# HISTORIC AND DESIGN REVIEW COMMISSION

**HDRC CASE NO:** 2024-106  
**ADDRESS:** 2619 MCCULLOUGH AVE  
**LEGAL DESCRIPTION:** NCB 1704 BLK 12 LOT N1-2 OF 12 & 13  
**ZONING:** O-1, H  
**CITY COUNCIL DIST.:** 1  
**DISTRICT:** Monte Vista Historic District  
**APPLICANT:** Bertha Zuniga/Zuniga Law, PLLC  
**OWNER:** Bertha Zuniga/Zuniga Law, PLLC  
**TYPE OF WORK:** Fenestration modifications and infill of eight wood windows  
**APPLICATION RECEIVED:** March 07, 2024  
**60-DAY REVIEW:** May 6, 2024  
**CASE MANAGER:** Claudia Espinosa

The applicant is requesting a Certificate of Appropriateness for approval to:

1. Remove and infill eight wood windows on the north and south façade of the second-floor previously enclosed porch.
2. Replace the five existing operable windows on the south façade with fixed windows.

Modifications on the south facade, circa 2024

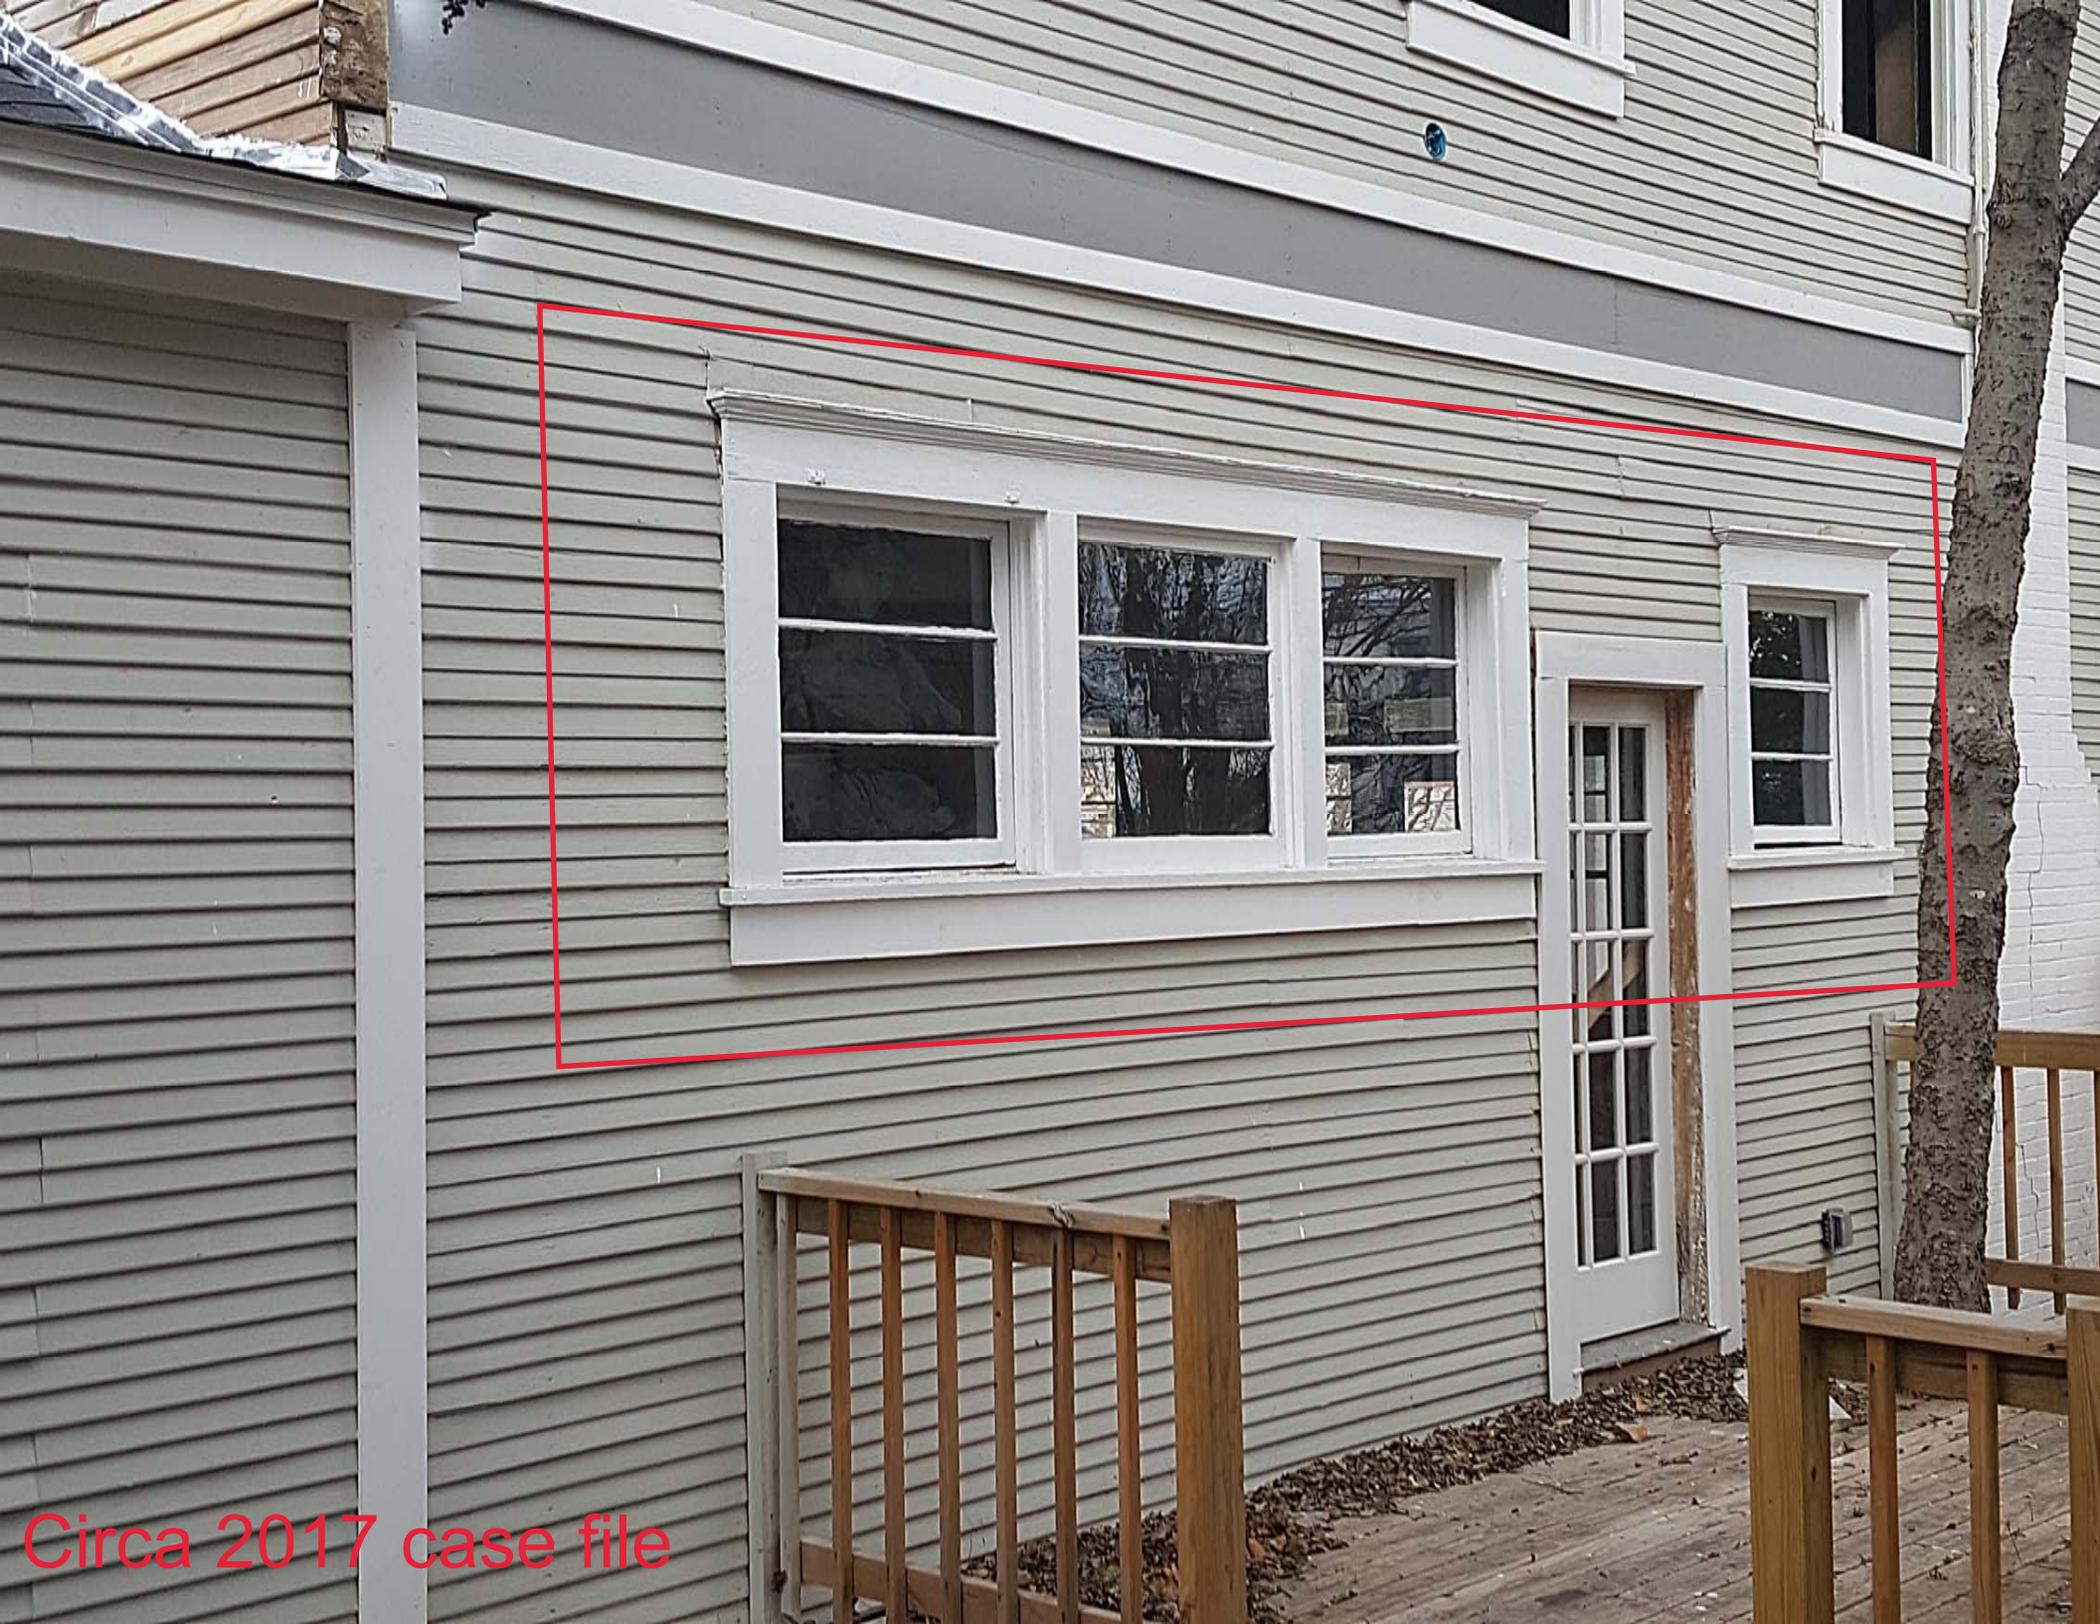
d. WINDOW REPLACEMENT (SOUTH FAÇADE) – Per the photos taken on the site visit, staff was able to locate additional windows that have been modified without approval. Per the Guidelines for Exterior Maintenance and Alterations 6.B.iv, Install new windows to match the historic or existing windows in terms of size, type, configuration, material, form, appearance, and detail when original windows are deteriorated beyond repair. Staff has not been able to assess any windows prior to the modifications were made. At this time, staff finds that the applicant submits a window schedule, photos of the interior and exterior of each window requested for replacement, numbered to correspond to the floor plan, material specifications of the existing windows, photos or manufacturer’s specifications, including material specifications, for the proposed replacement product (typically in the form of a cutsheet) to staff for review.

e. WINDOW OPENING MODIFICATION (SOUTH FACADE) – The applicant has proposed to modify five (5) window opening on the south façade of the original structure by shortening the overall size of the opening. The Guidelines for Exterior Maintenance and Alterations 6.A.i. notes that existing window and door openings should be preserved. Staff finds the proposed modifications to be inconsistent with the Guidelines.

Item 2, staff does not recommend approval of the window replacement on the south façade, based on finding d. Staff recommends that the applicant reinstall the wood windows that were previously in place or a salvaged product that replicates the previously installed windows in size, operation, design, and configuration.

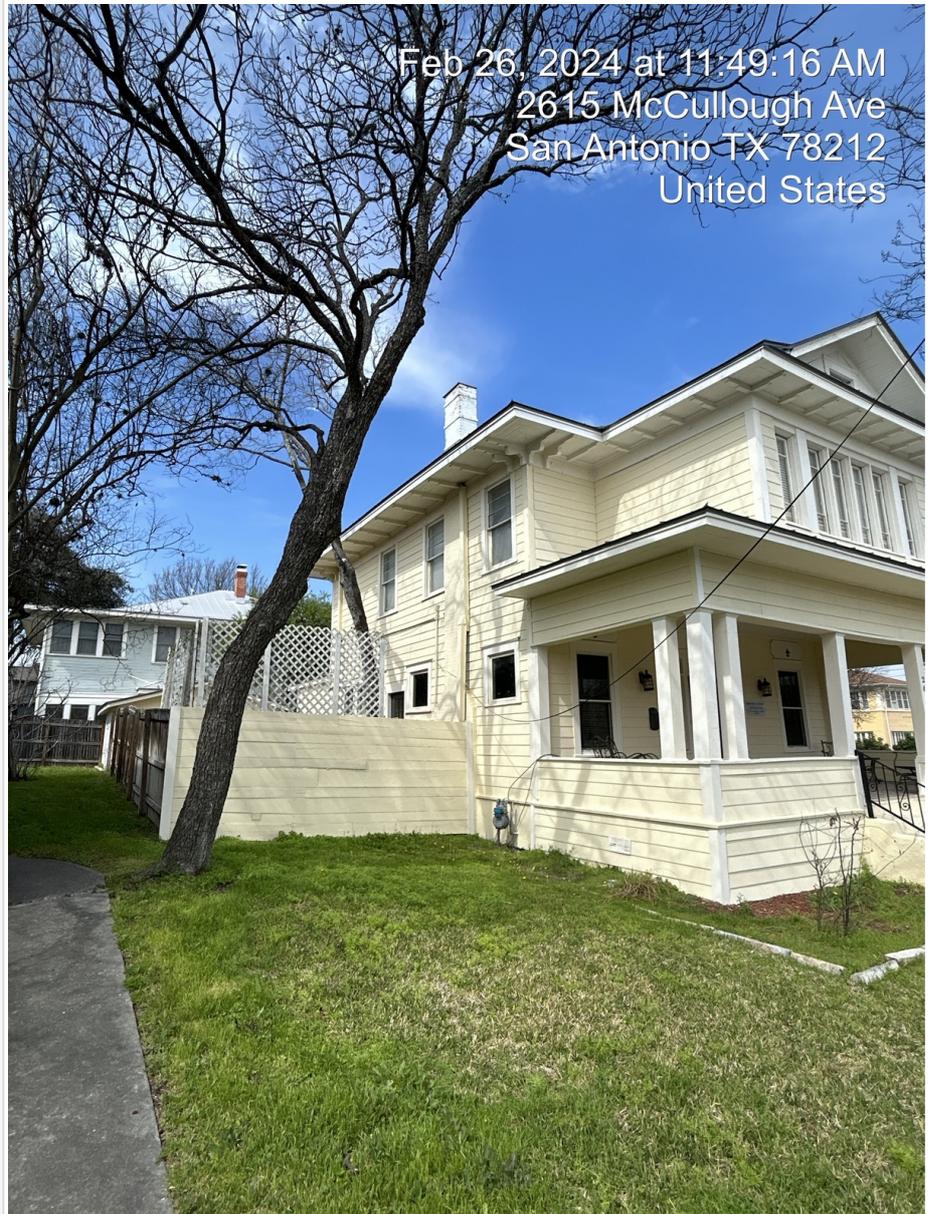
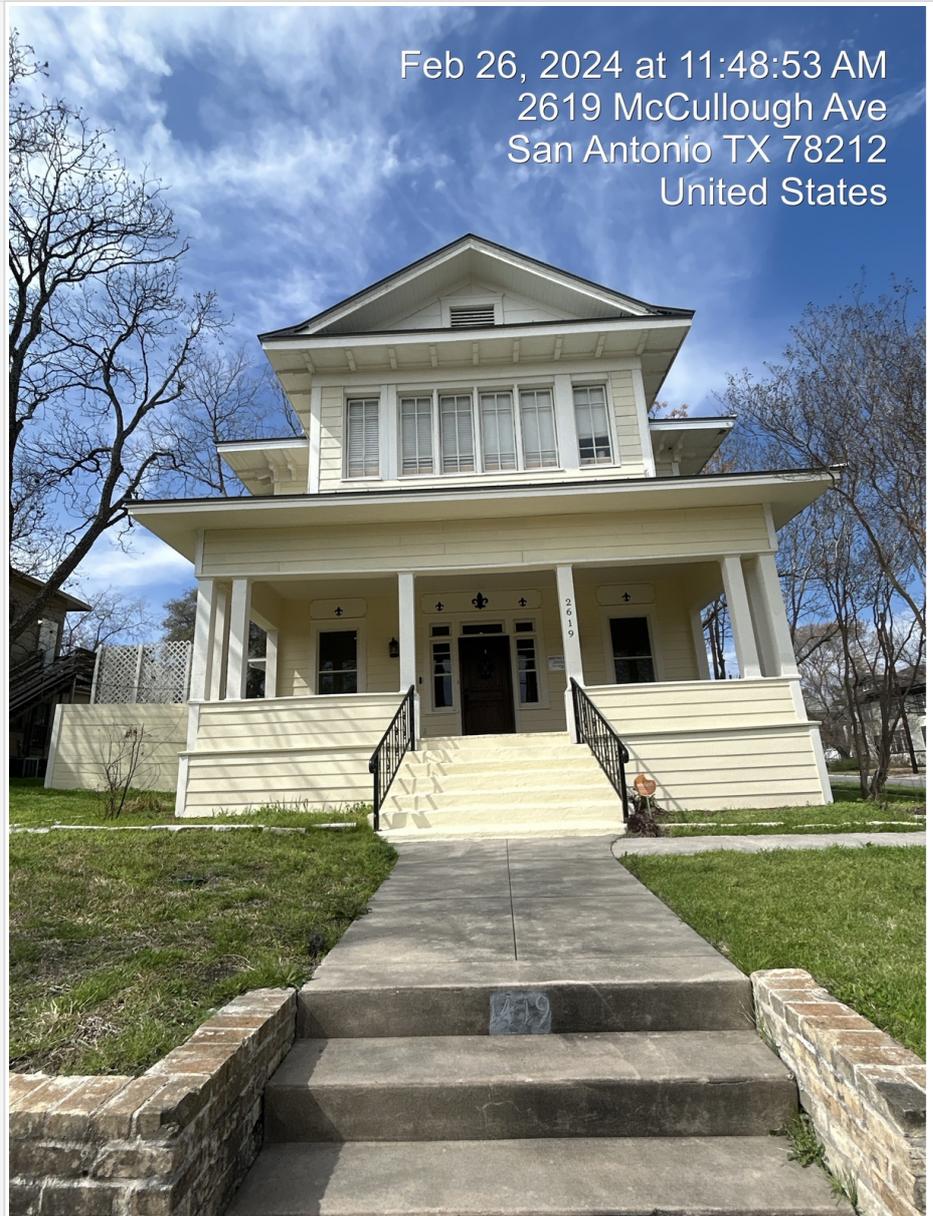
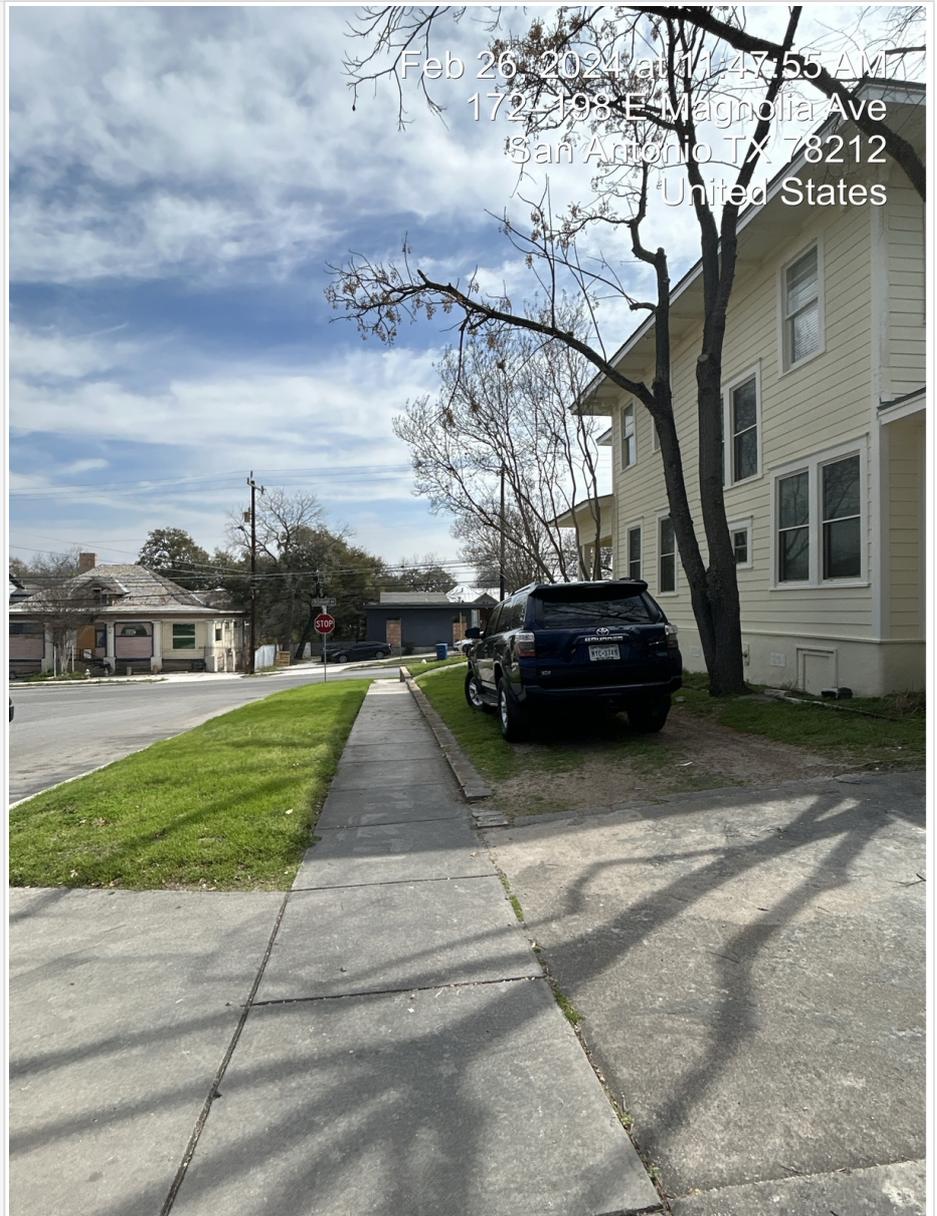
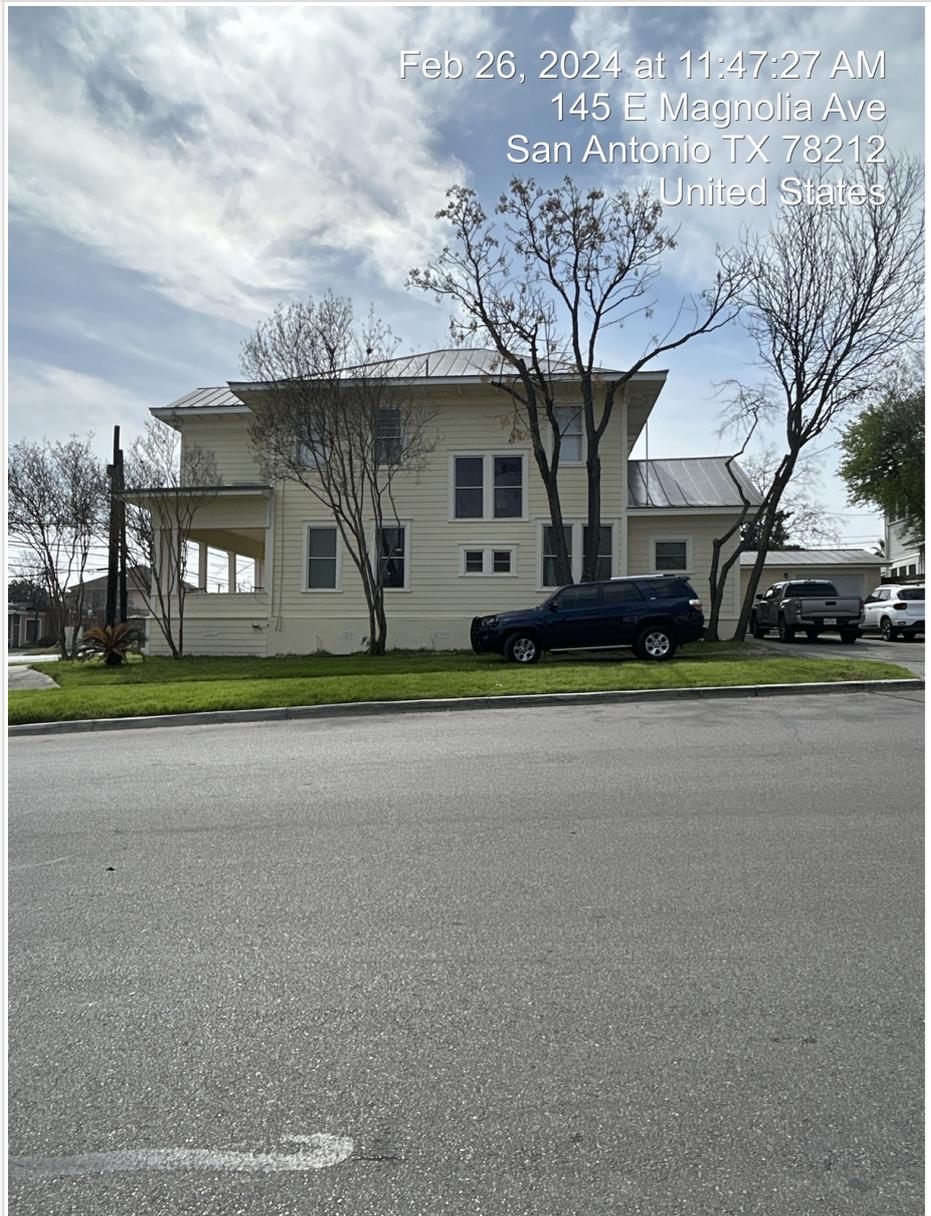
| Description of work        | Wood window removal and infill  |
| Description of interaction | Staff spoke with the property owner regarding the reported scope of work. The property owner stated she made the decision to remove windows on the north and south facade on the second floor sunroom and infill the openings without approval. Staff discussed the COA process and the CTAB process. The property owner stated she would apply for a COA regarding the infill. As of today, 3/4/2024, no application is on file. |
